**PCN# 20091102000  
SPQ/MOQ and pack materials change for select devices in the RGY package  
Information Only**

<b>PCN Number:</b>	20091102000		<b>PCN Date:</b>	11/10/2009	
<b>Title:</b>	SPQ/MOQ and pack materials change for select devices in the RGY package				
<b>Customer Contact:</b>	<a href="#">PCN Manager</a>	<b>Phone:</b>	+1(214) 480-6037	<b>Dept:</b>	Quality Services
<b>Proposed 1<sup>st</sup> Ship Date:</b>	N/A		<b>Estimated Sample Availability:</b>	Date provided at sample request	
<b>Change Type:</b>					
<input type="checkbox"/>	Assembly Site	<input type="checkbox"/>	Assembly Process	<input type="checkbox"/>	Assembly Materials
<input type="checkbox"/>	Design	<input type="checkbox"/>	Electrical Specification	<input type="checkbox"/>	Mechanical Specification
<input type="checkbox"/>	Test Site	<input checked="" type="checkbox"/>	Packing/Shipping/Labeling	<input type="checkbox"/>	Test Process
<input type="checkbox"/>	Wafer Bump Site	<input type="checkbox"/>	Wafer Bump Material	<input type="checkbox"/>	Wafer Bump Process

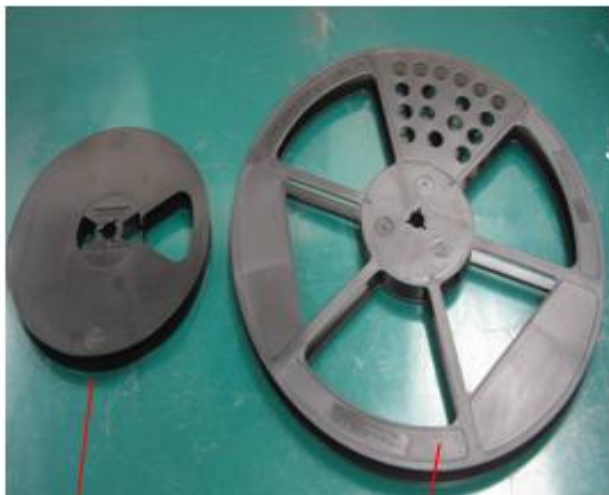
The standard pack quantity (SPQ) for the devices in the Product Affected list is changing from 1000 to 3000, The reel and shipping box will also be changing per the table below. The 13" reel and shipping box are currently used at TI assembly sites for devices in other packages. See attachment 'A' for dimensional changes.

<u>Desc/ part numbers</u>	7"	13"
SPQ	1000	3000
Reel	4203839-0006	4203160-0011
Ship Box	4206831-0001	4207162-0007

## Attachment 'A'

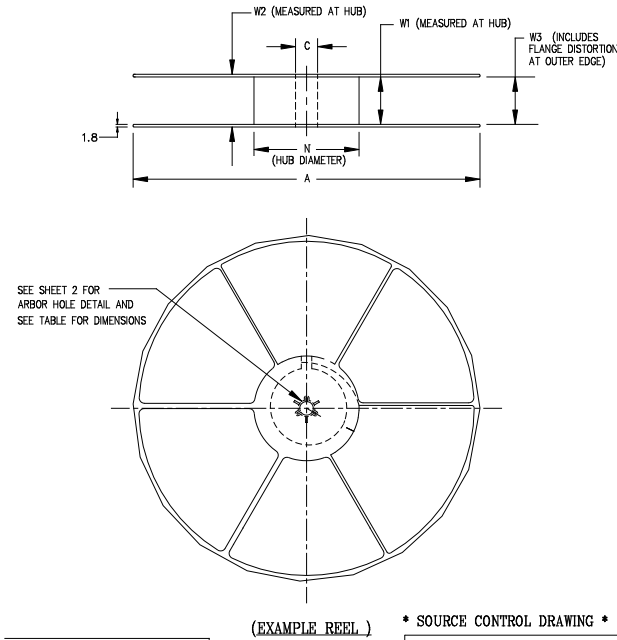
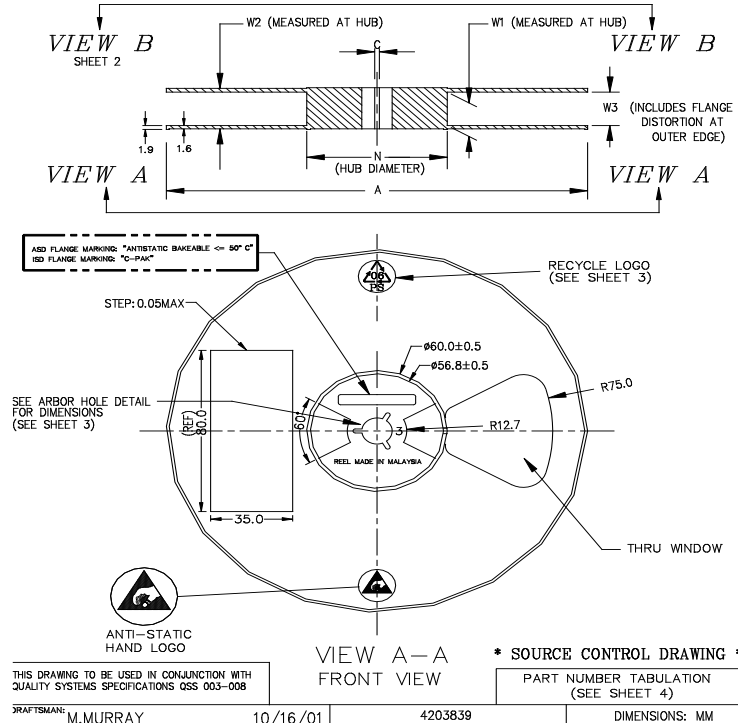
TI will be changing part number 4203839-0006 for a 7" outer diameter reel to part number 4203160-0011 for a 13" outer diameter reel.

Part#	MATL TYPE	TAPE SIZE (MM)	A (MAX)	B (±0.5)	C (±0.2)	D (MIN)	E (MIN)	N (MIN)	W1 (+2.0/-0.0)	W2 (MAX)	W3 (MIN/MAX)
4203839-0006	ASD	12	180	1.5	13	20.2	2.5	60	12.4	18.4	11.9/15.4
4203160-0011	PS	12	330	2	13	20.8	N/A	100±1.0	12.4	18.4	11.9/15.4
